FITZSIMONS GATEWAY MULTIFAMILY | SITE PLAN

LOT 2, BLOCK 1 FITZSIMONS PROMENADE SUBDIVISION FILING NO. 1 AMENDMENT 1
LOCATED IN THE NORTHWEST 1/4 OF SECTION 1, TOWNSHIP 4 SOUTH, RANGE 67 WEST OF THE 6TH P.M.,
CITY OF AURORA, COUNTY OF ARAPAHOE, STATE OF COLORADO

AMENDMENTS

DATE:
08/24/22 - SITE PLAN 01
10/17/22 - SITE PLAN 02
11/23/22 - SITE PLAN 03
12/19/22 - SITE PLAN 04
02/13/23 - SITE PLAN 05
05/17/23 - MINOR AMD 01-1
12/08/23 - MINOR AMD 01-2
01/30/24 - MINOR AMD 01-3
12/12/24 - MINOR AMD 02-1
01/06/25 - MINOR AMD 02-2

SHEET TITLE:
**HARDSCAPE
PLAN**

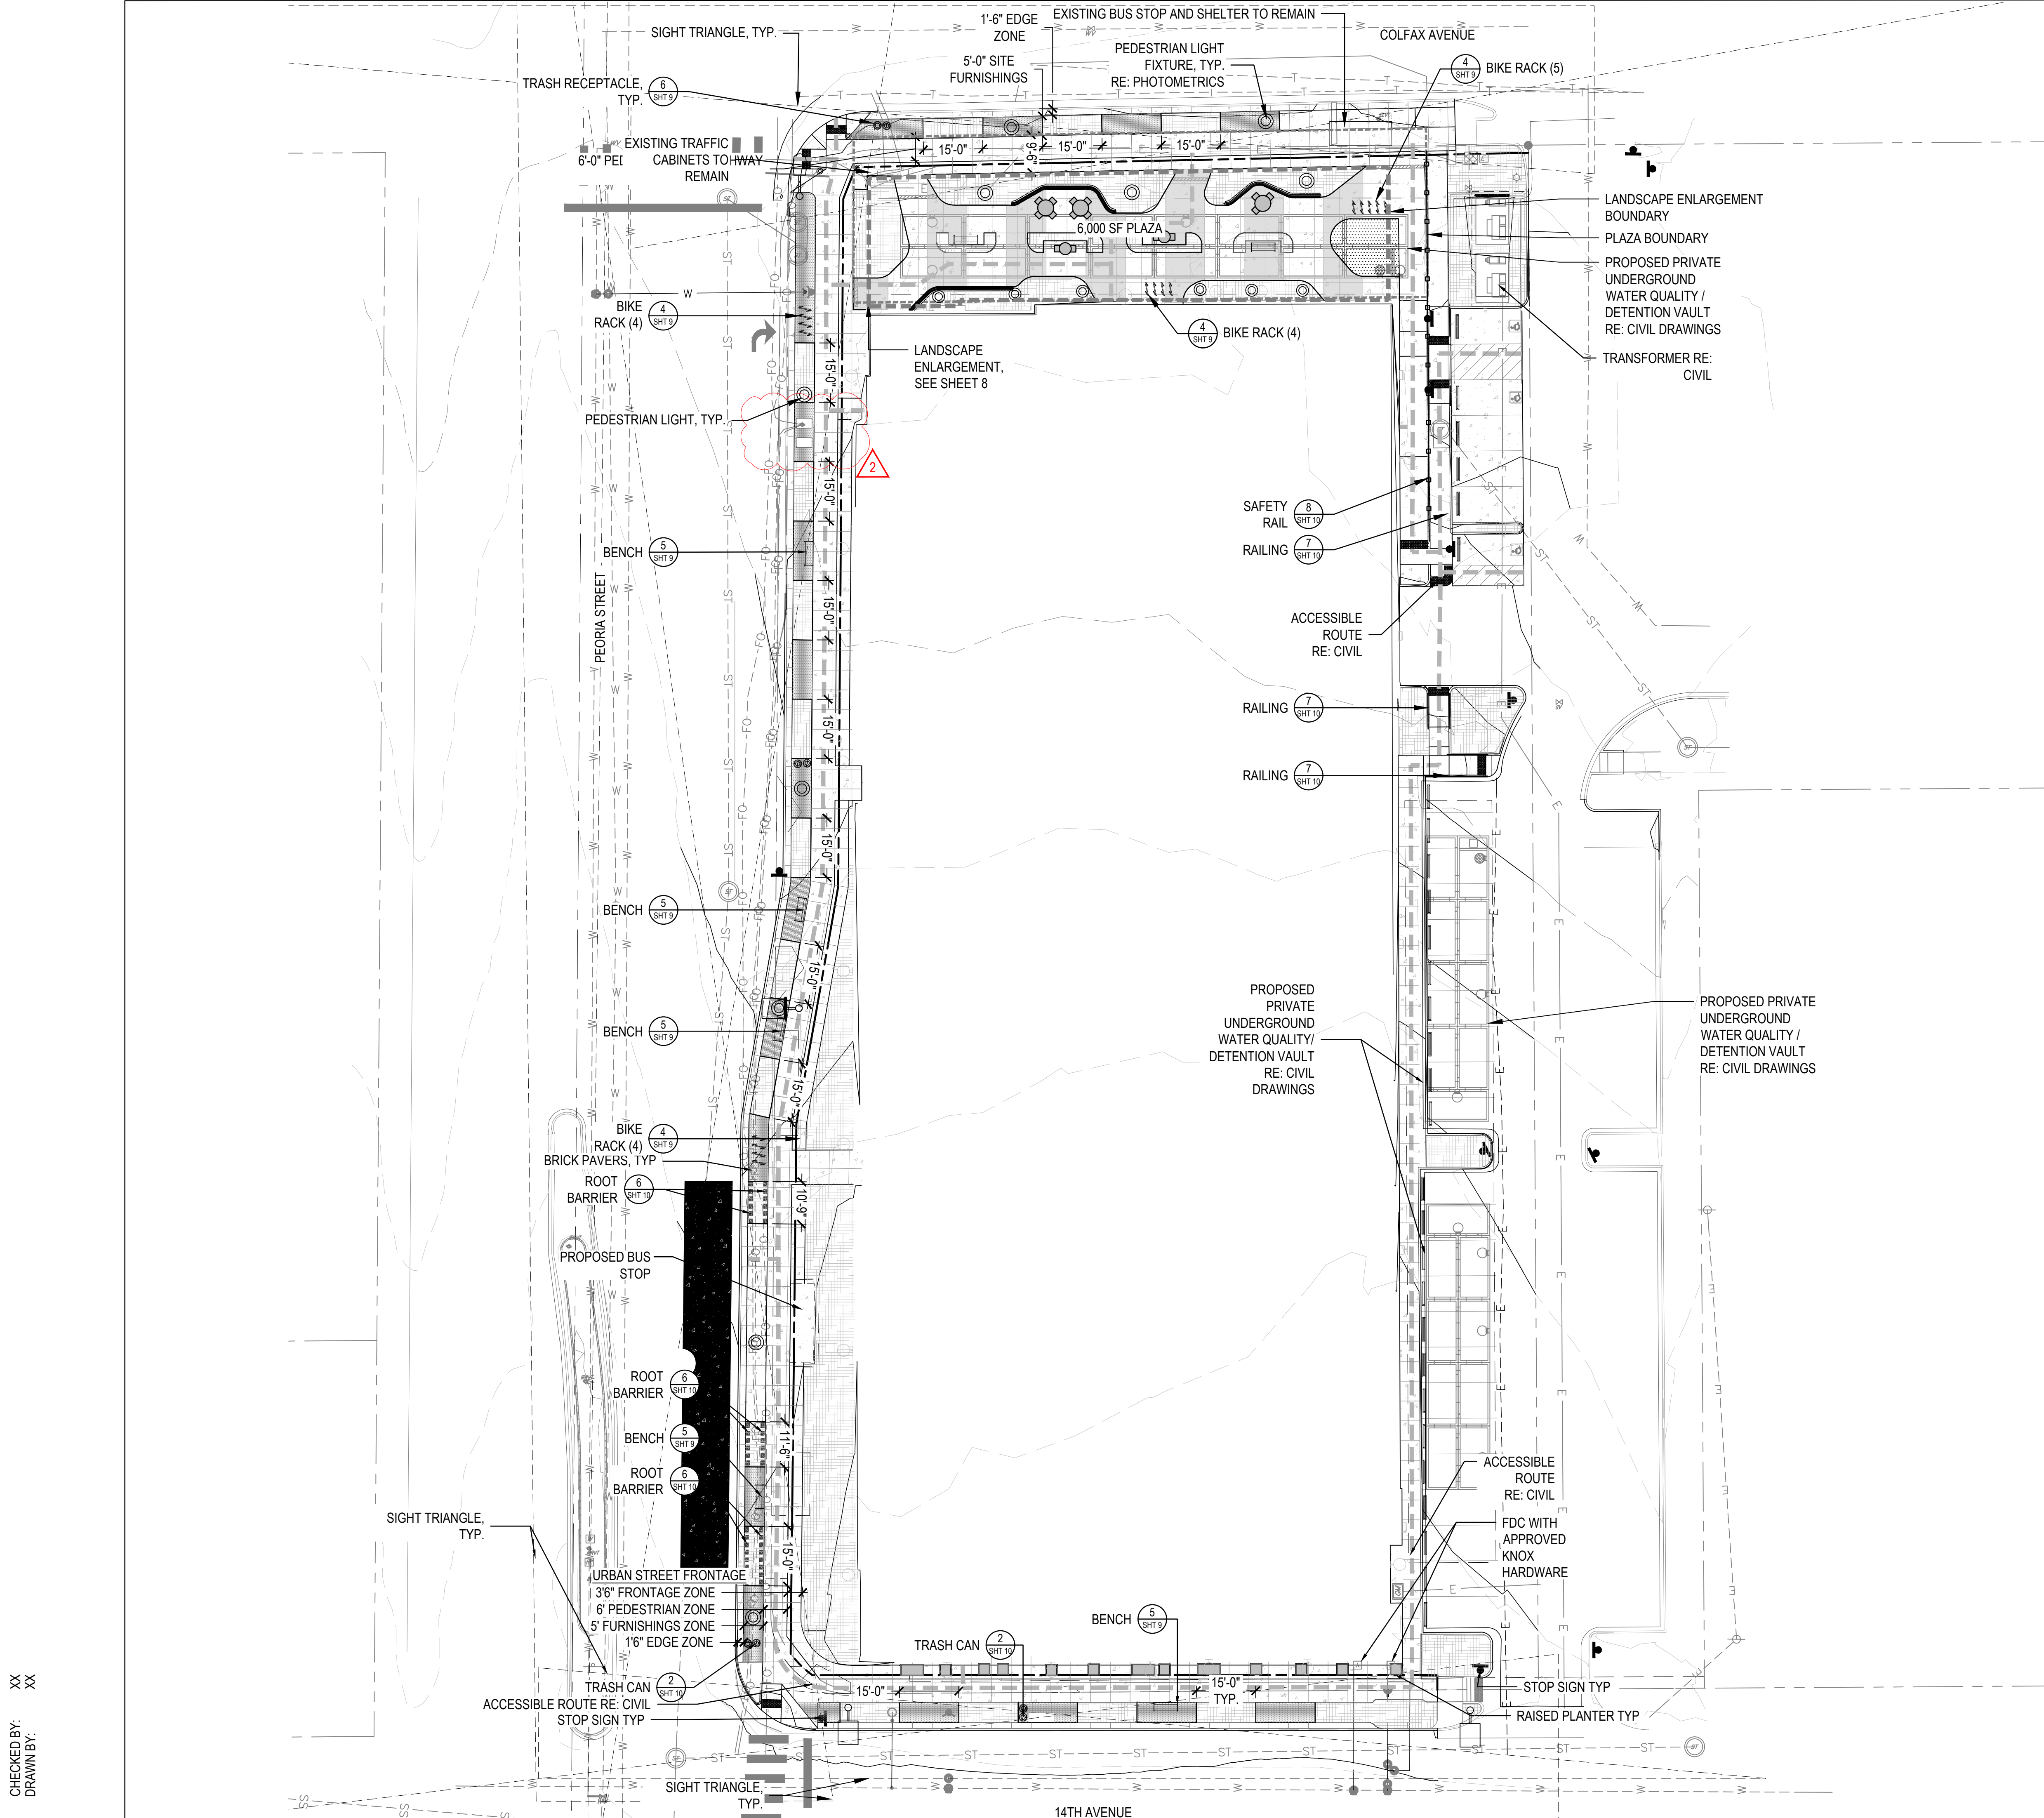
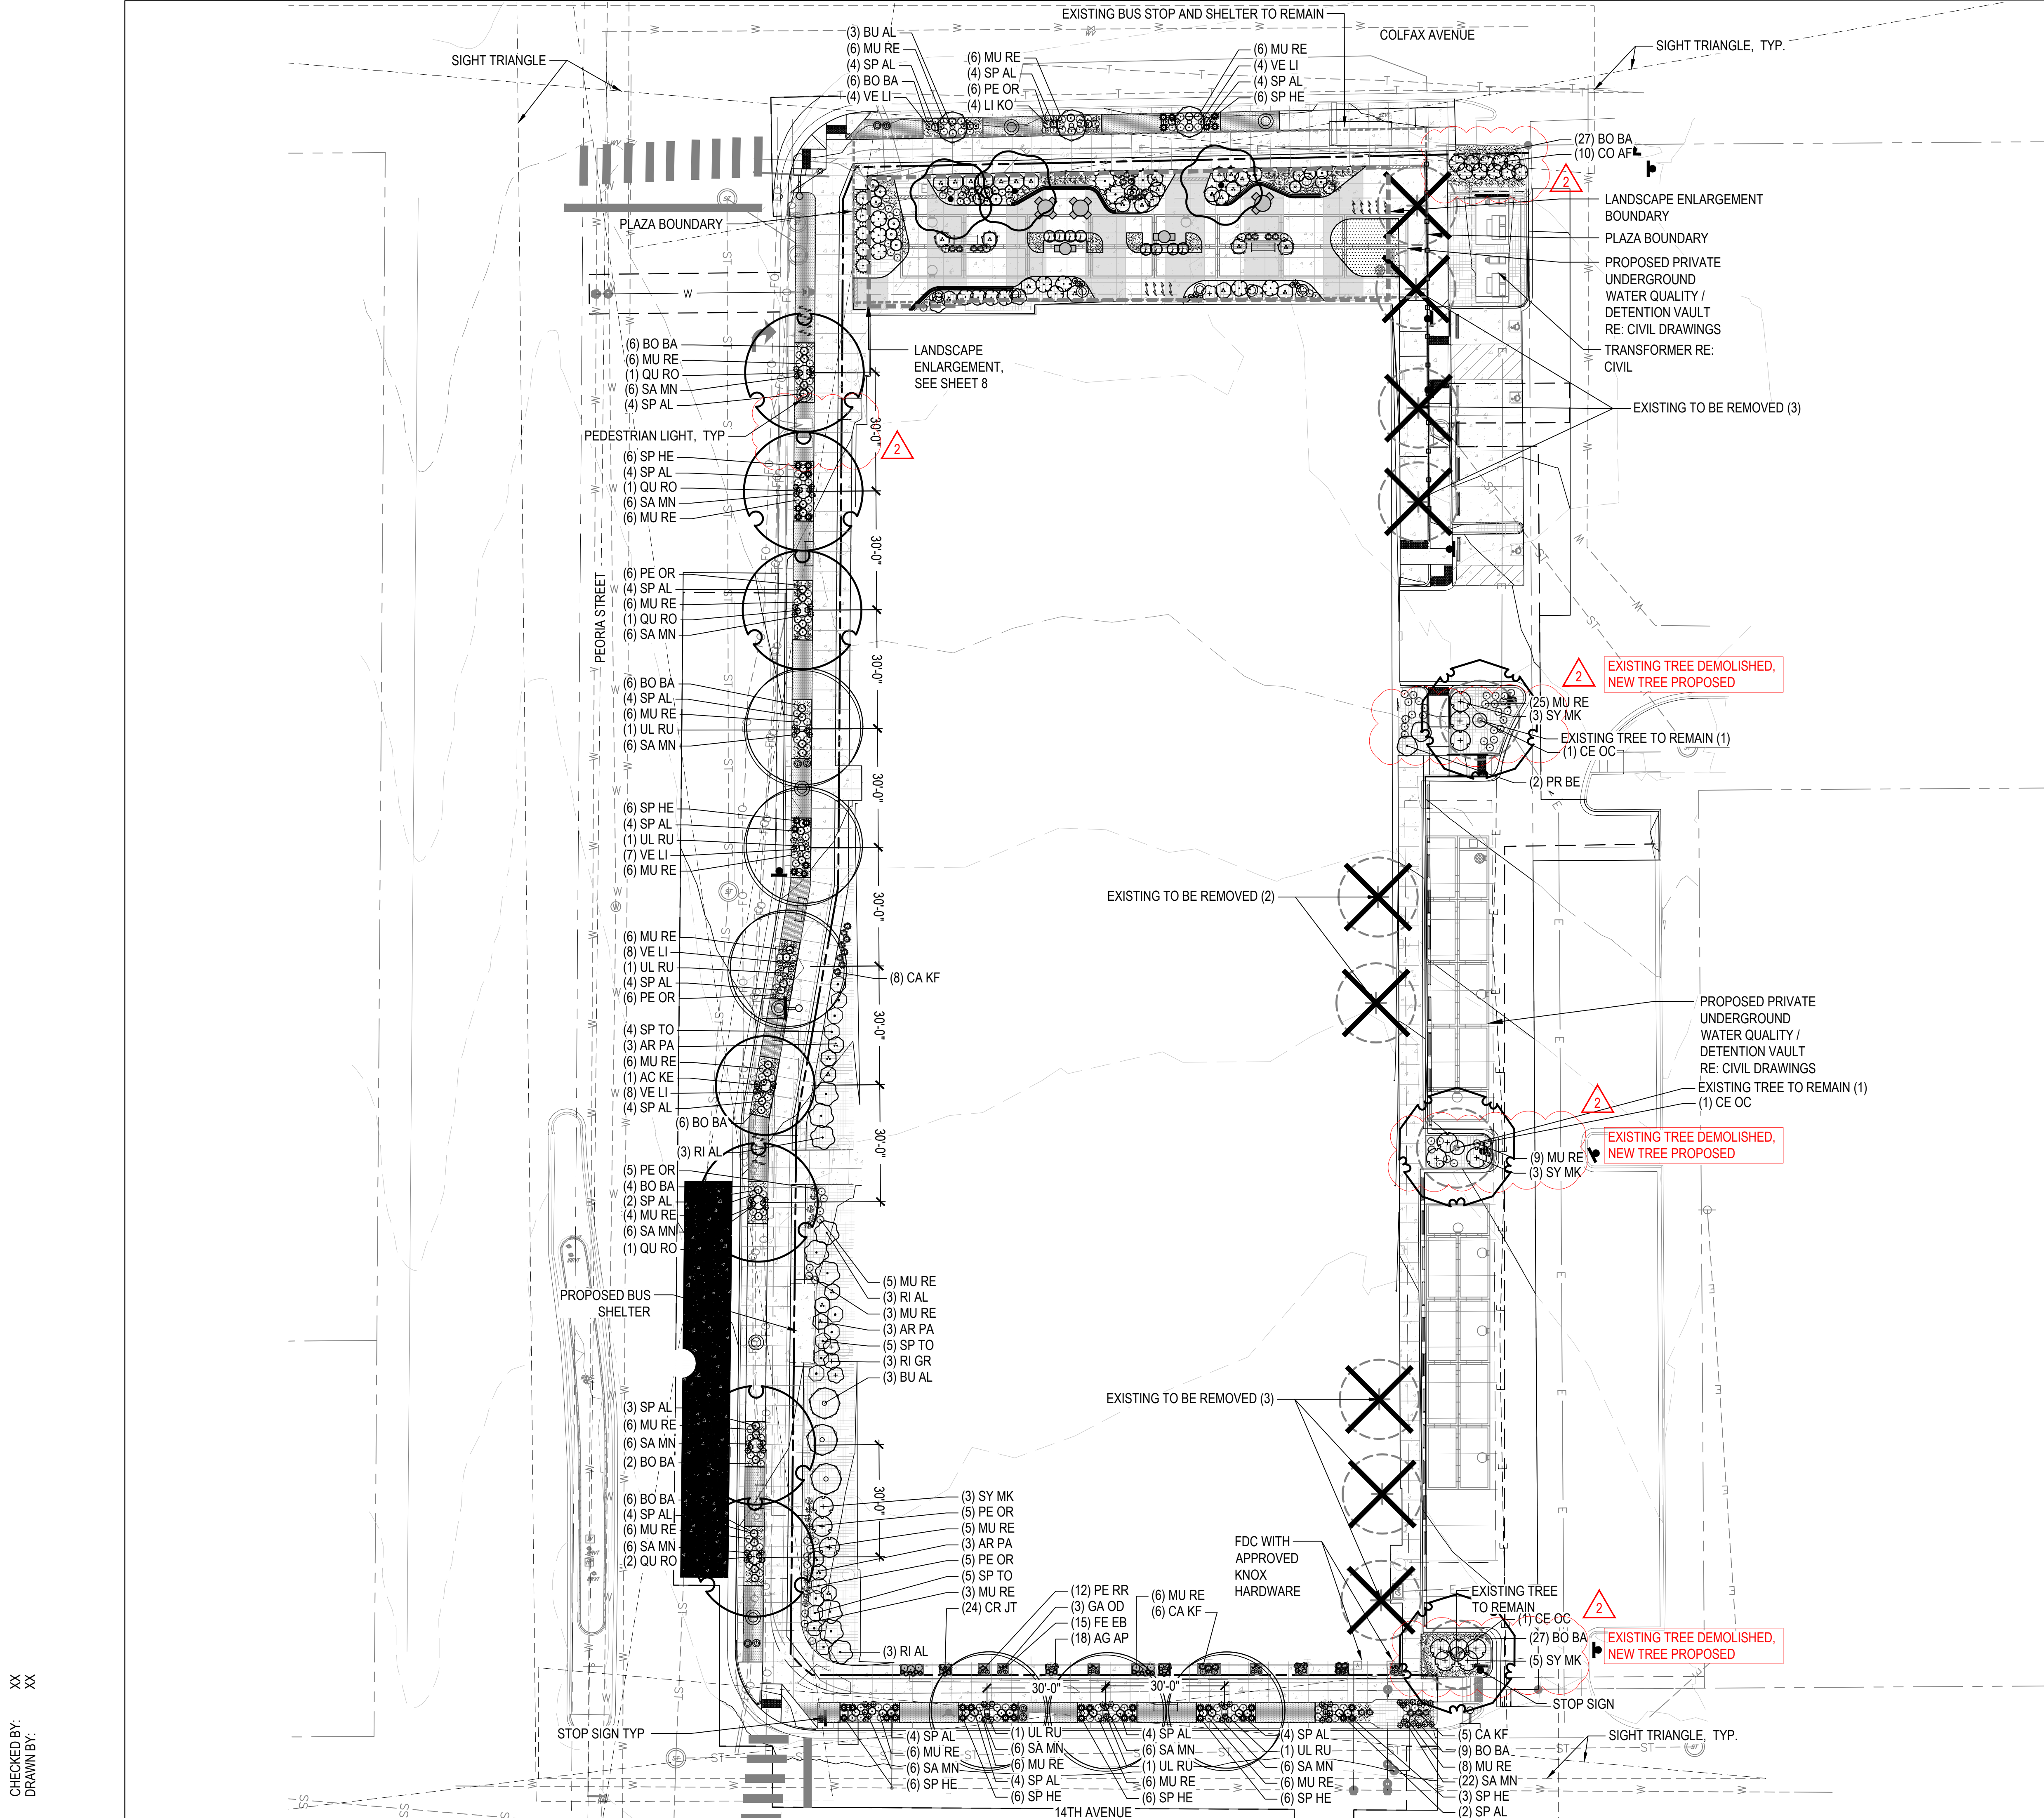
- ▲ 12/08/2023 MA: 2022-4047-01
- TRANSFORMERS HAVE BEEN RELOCATED TO THE NORTH TO AVOID CONFLICT WITH STORMLINE AT PRIOR LOCATION; PARKING HAS BEEN RELOCATED TO THE SOUTH WITH NO CHANGES TO NUMBER OF STANDARD OR ACCESSIBLE SPACES. UPDATES SHOWN ON SITE PLAN, UTILITY & GRADING PLAN, HARDSCAPE PLAN, LANDSCAPE PLAN, LANDSCAPE ENLARGEMENTS, AND OVERALL PHOTOMETRIC PLAN.

- CURB RAMPS ADDED TO SITE PLAN SHEET TO SHOW ACCESSIBLE TRANSITION FROM ACCESSIBLE PARKING SPACES TO SIDEWALK ON THE EAST SIDE OF THE BUILDING. UPDATES SHOWN ON SITE PLAN, UTILITY & GRADING PLAN, HARDSCAPE PLAN, LANDSCAPE PLAN, LANDSCAPE ENLARGEMENTS, AND OVERALL PHOTOMETRIC PLAN.
